Union Electric Company  
1901 GRATIOT STREET  
ST. LOUIS, MISSOURI

August 19, 1981

ULNRC- 483

DOCKET NUMBERS 50-483 AND 50-486  
CALLAWAY PLANT, UNITS 1 & 2  
FINAL SAFETY ANALYSIS REPORT

FIGURE 2.2-4

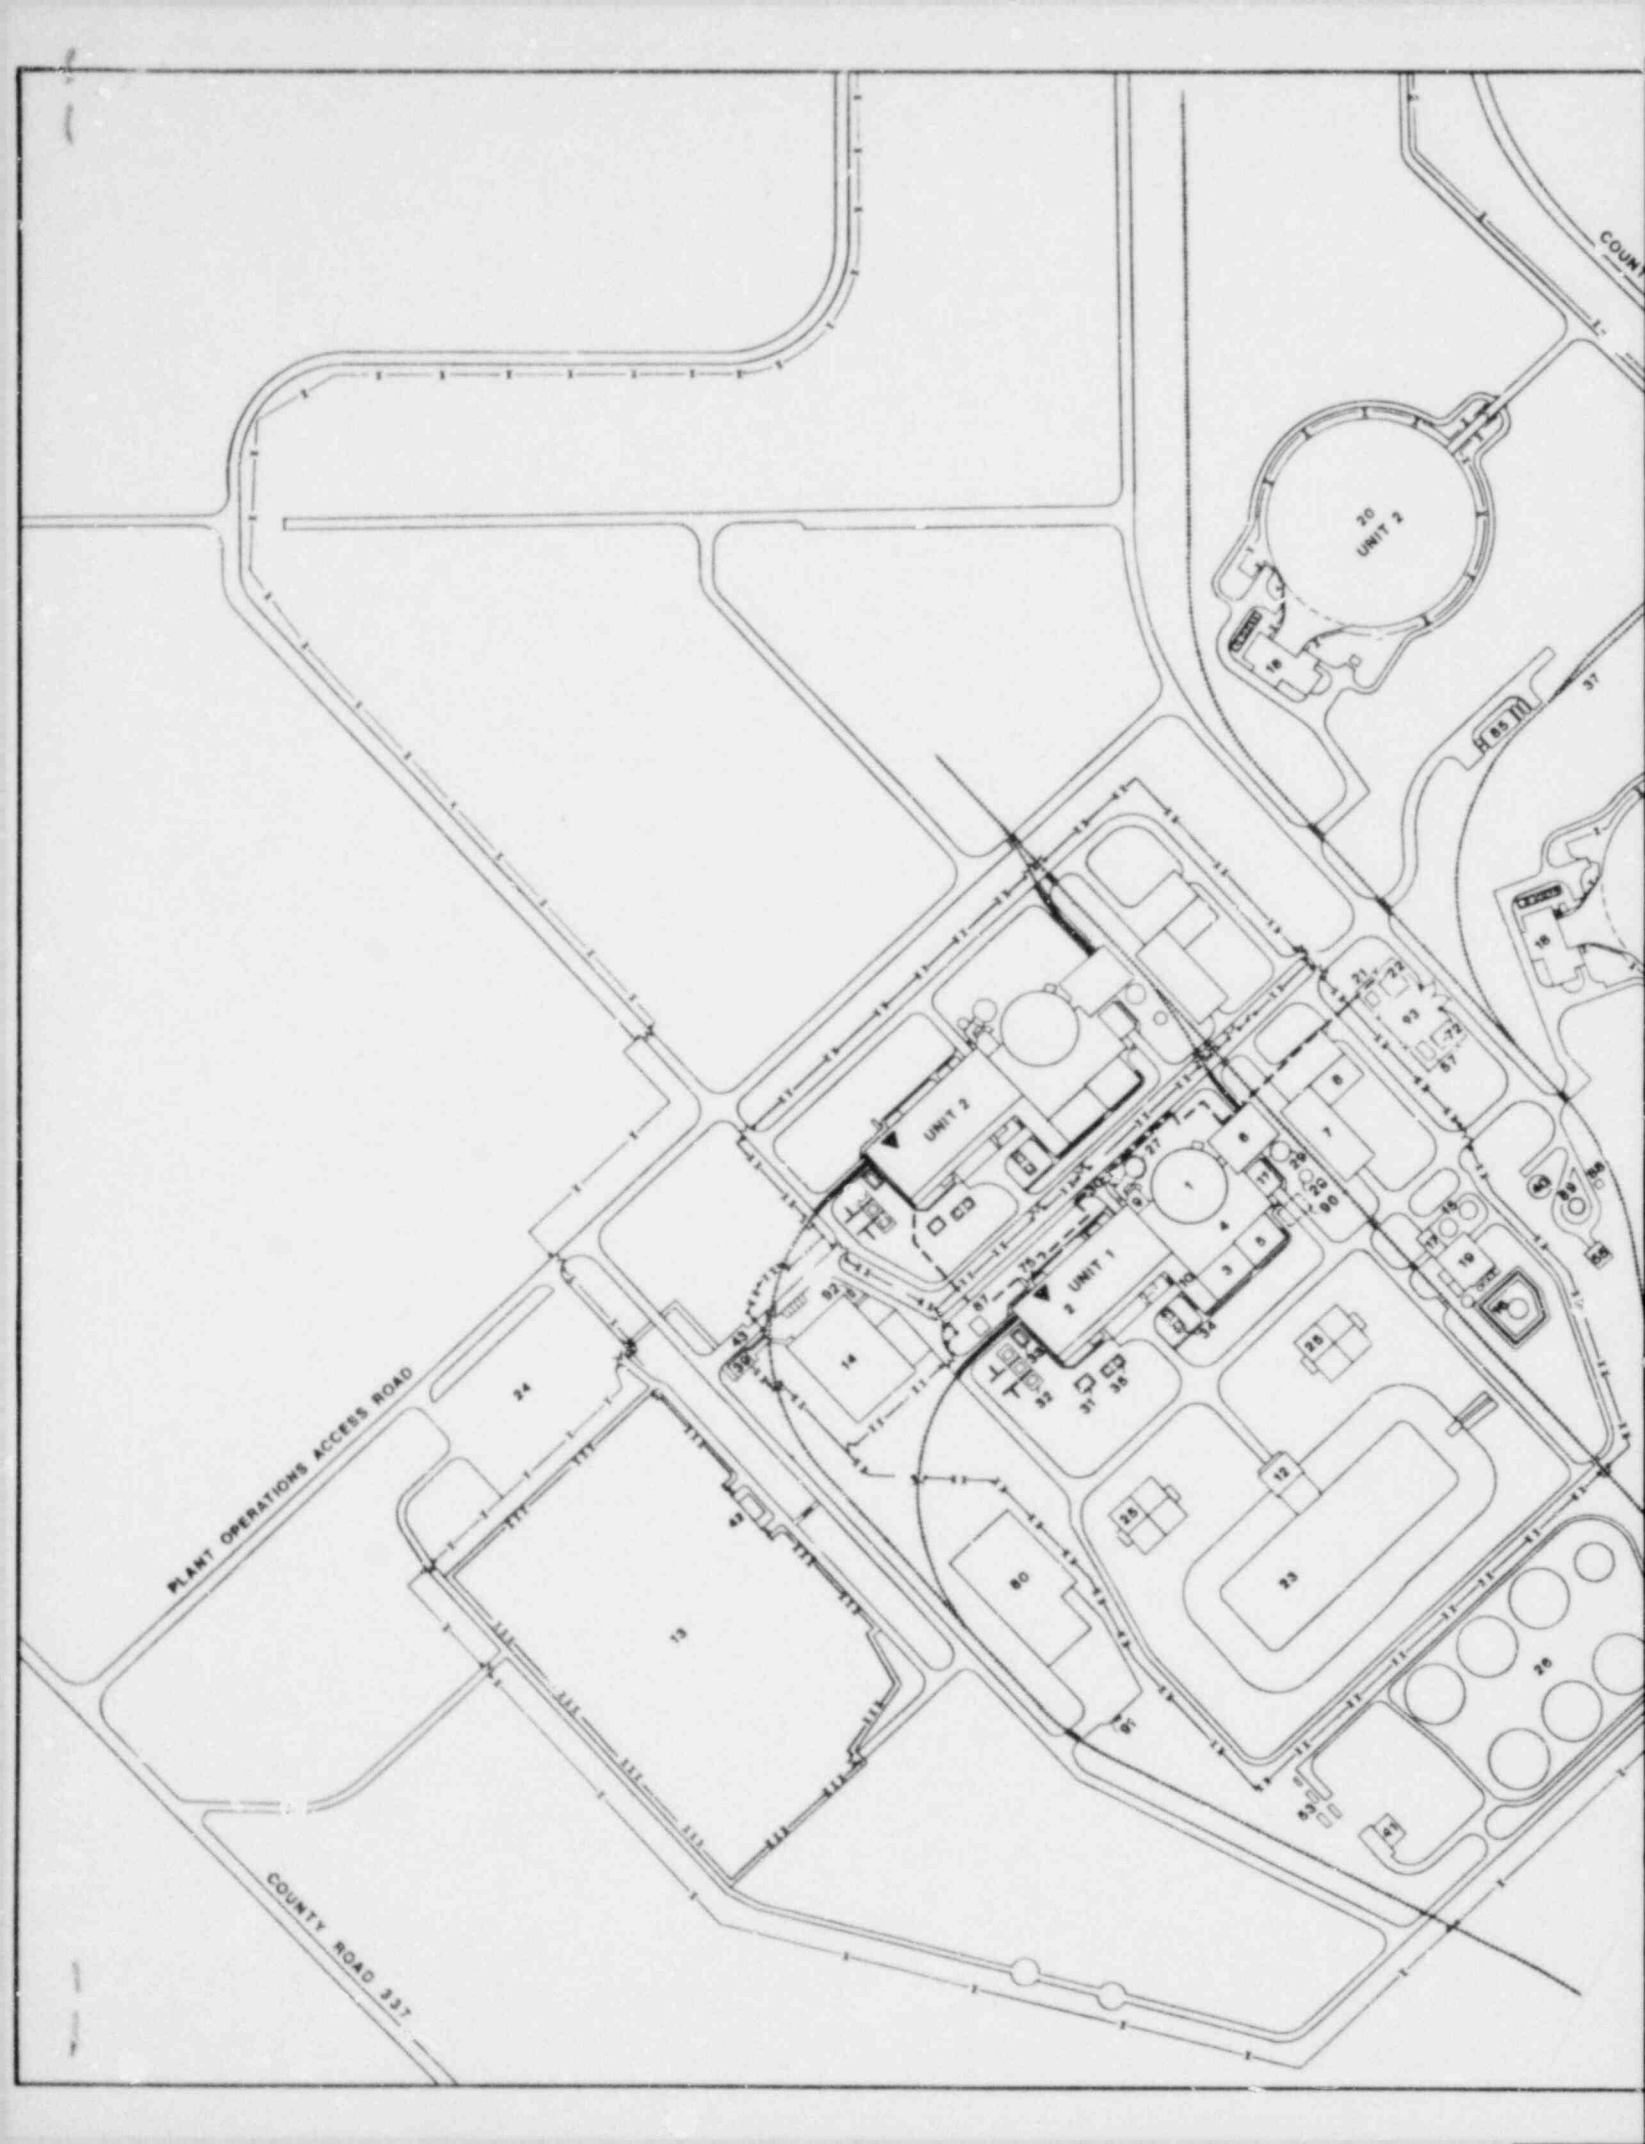
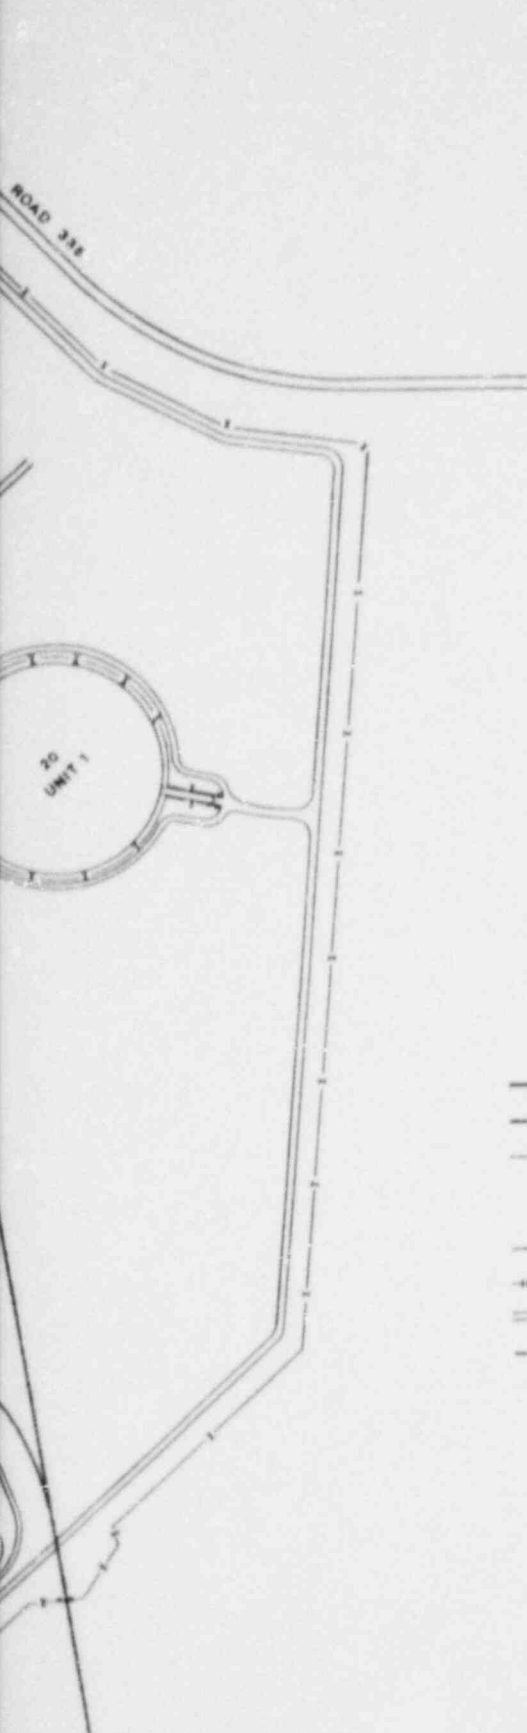
| The location of the HS bulk storage facility and the distribution piping outside the Standard Power Blocks are shown on Figure 2.2-4. A flow diagram of the HS is shown in Figure 2.2-5. The hydrogen storage system is located plant South of and approximately 350 feet away from the Power Block. The axes of the pressure vessels are oriented plant East-West and are not directed at any of the buildings within the plant site. Due to the distance between the Power Block and the hydrogen storage area a fire in the storage area does not pose any hazard to systems required for safe shut-down. The hydrogen storage system for each unit will sit on its own grade-level concrete foundation slab and the rest of the fenced gas storage area will be rock-covered and kept brush free to prevent any brush fire from impinging on the storage tanks. There is a fire hydrant and hose house within 160 feet of the storage facility.
